## **COUNCIL SUBMISSION - Environmental Impact Statement (EIS) for Sydney Metro West Stage 3 – Rail infrastructure, stations, precincts, and operations**

City of Parramatta Council (Council) thanks the NSW Department of Planning and Environment (DPE) for the opportunity to provide a submission to this public exhibition of the EIS for the Sydney Metro West Stage 3 – Rail infrastructure, stations, precincts and operations (the Project). Council looks forward to continuing to work closely and proactively with DPE and Sydney Metro on this critical Project.

Figure 1: Public Domain, Street & Deep Soil provision

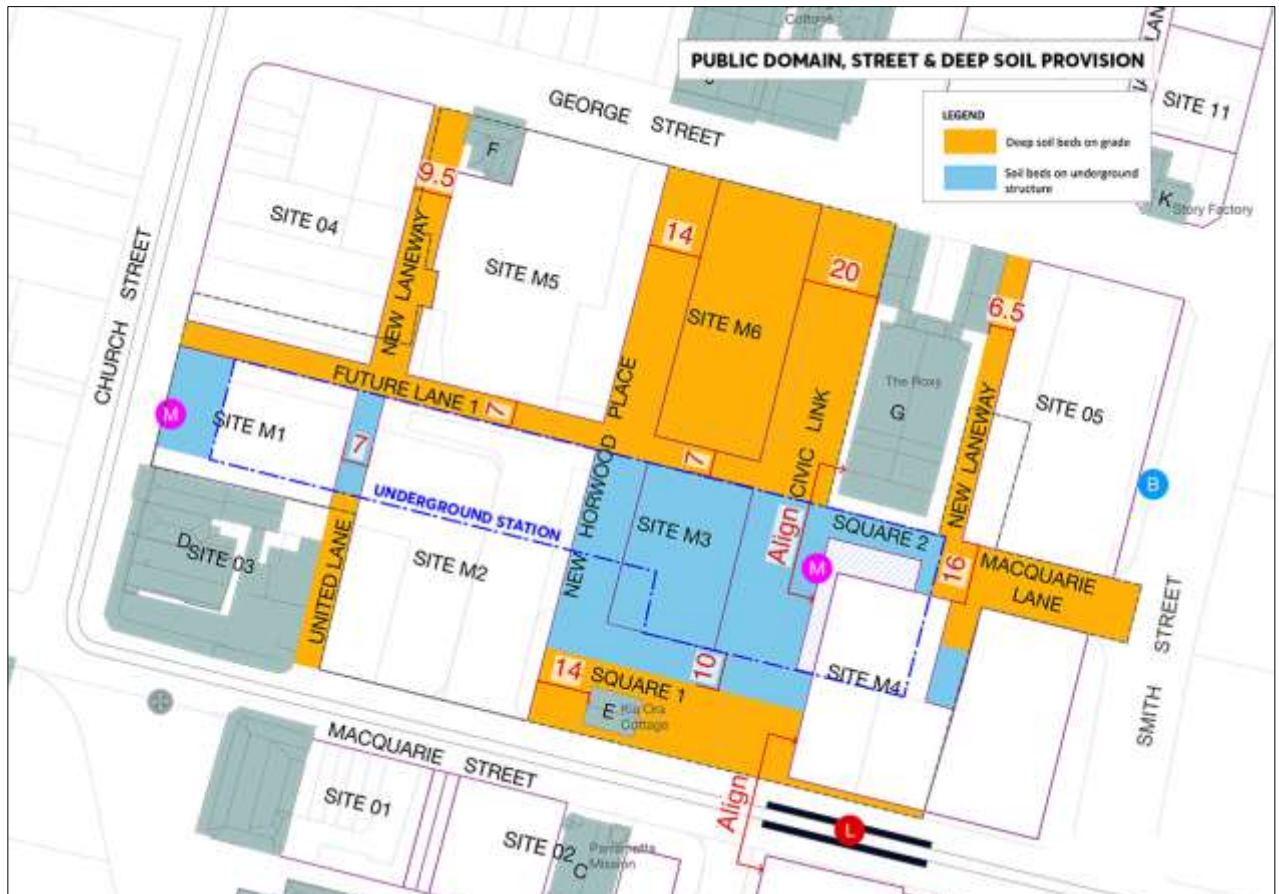
Hence, Council proposes the conditioning of Figure 1 – Public Domain, Street and Deep Soil provision, Table 1 – Deep Soil Beds on Grade (City of Parramatta Public Domain Guidelines), Table 2 - Requirements for Soil Beds on Underground Structure (2015 Apartment Design Guide – DPE) and Figure 3 – Soil Bed Depth on Underground Structure – all contained within **Attachment 1**.

The basement structures to support future over and adjacent station development, along with the Station Box fit out, must be designed to provide the slab drop down to allow deep soil planting, per Figures and Tables in **Attachment 1**. It will be too late to leave this critical element to a 'future' approval, when the basement structures for future commercial development are part of this EIS and Planning Approval. It is recommended that:

- The SSI Planning Approval incorporate Figure 1 – Public Domain, Street and Deep Soil provision, Table 1 – Deep Soil Volume on Grade (City of Parramatta Public Domain Guidelines), Figure 2 – Deep Soil Depth on Grade, Table 2 - Soil Bed Volume on Underground Structure (2015 Apartment Design Guide – DPE), and Figure 3 – Soil Bed Depth on Underground Structure, as Conditions of Approval.
- That the SSI Planning Approval condition all vehicle access, service access, and parking for the proposed buildings to be wholly contained within the building footprints and not under public domain, as shown in Figure 1. Detailed access and servicing arrangements to adjacent properties to be the subject of a design to be developed by Sydney Metro in consultation with City of Parramatta (post consent and before the construction of the station and structures for non-station use).

- Provision for minimum 1800mm slab drop down or other mechanism for providing deep soil provision (Tables 1-2, Figures 1-3 in Attachment 1), must be conditioned within the Planning Approval for over station and adjacent station development within the Civic Link.
- Provision for minimum 3000mm slab drop down or other mechanism for provision of services, with service access provided from surface and no suspended services in underground structures for over station and adjacent station development within the Civic Link.

Figure 5: EIS 3 - Indicative layout plan of Clyde stabling

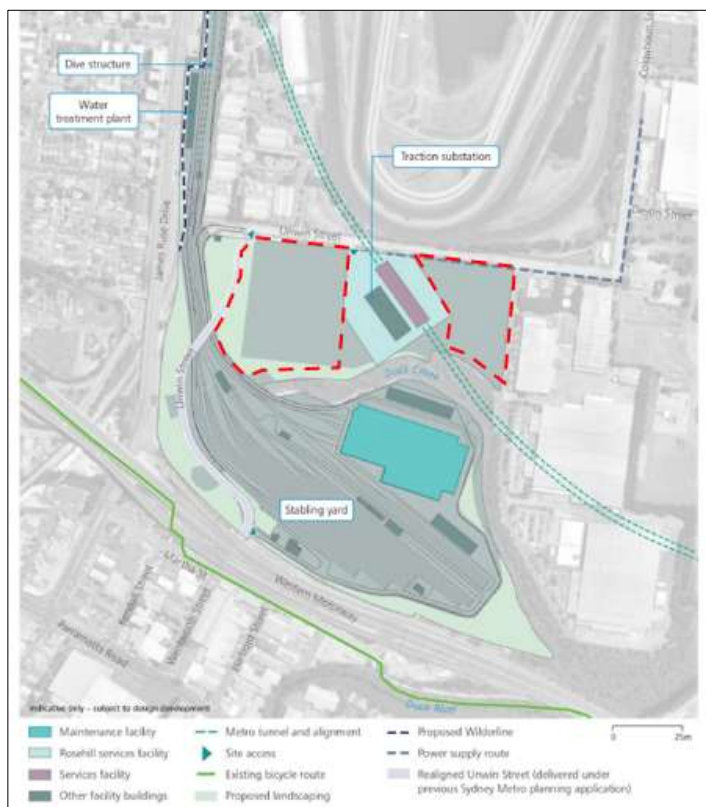
The first EIS and Planning Approval condition C B-2 required a recreation land offset for the loss of the Parramatta Speedway. The siting and design of the Rosehill services facility will need to consider the future land uses identified in the Draft Camellia-Rosehill Place Strategy. Essential community open space infrastructure has been earmarked to be located on residual land as marked in red in Figure 4 (extract from the draft Camellia-Rosehill Place Strategy) and Figure 5 (Indicative Layout Plan, EIS pg.17-4) in **Attachment 1**.

In this respect, the GRC Hydro hydraulic flood concept Report forming part of the first Planning Approval has superseded aspects of this EIS in providing a combined flood detention basin and recreation space in this residual area. There is sufficient room on the site for the Metro Rosehill Services facility and the provision of sporting fields on the residual land and flood detention basin. Refer Figure 6 and 7 within **Attachment 1**.

- The Clyde Stabling and Maintenance Facility Indicative Layout Plan should be updated to reflect the location of community sport and recreational infrastructure on residual Sydney Metro land consistent with the draft Camellia–Rosehill Place Strategy, per Figure 7 in Attachment 1 of this submission.
